Inspection of Automatic Sprinkler System

AW6 Molan Pino East London Industrial Development Zone

UNC8474

Photo 6

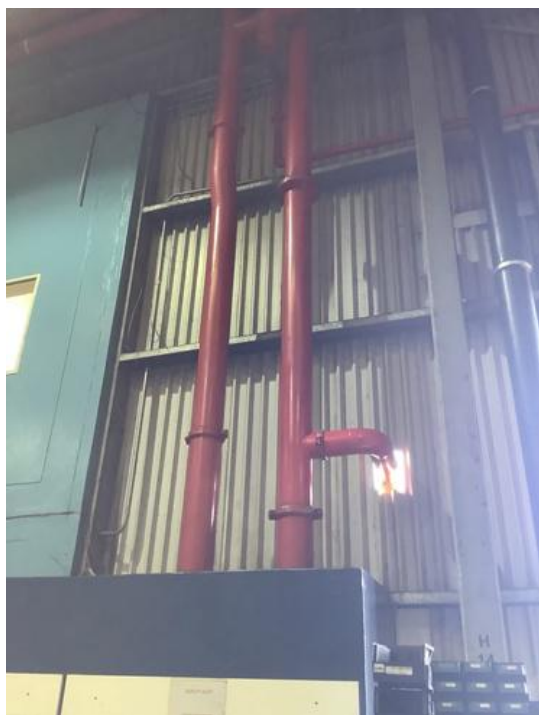
It appears that the booster connection piping to the main distribution riser is too long, which may restrict the opening of the booster plunger into the main distribution riser, this will prevent effective boosting of the sprinkler system and must be revised.
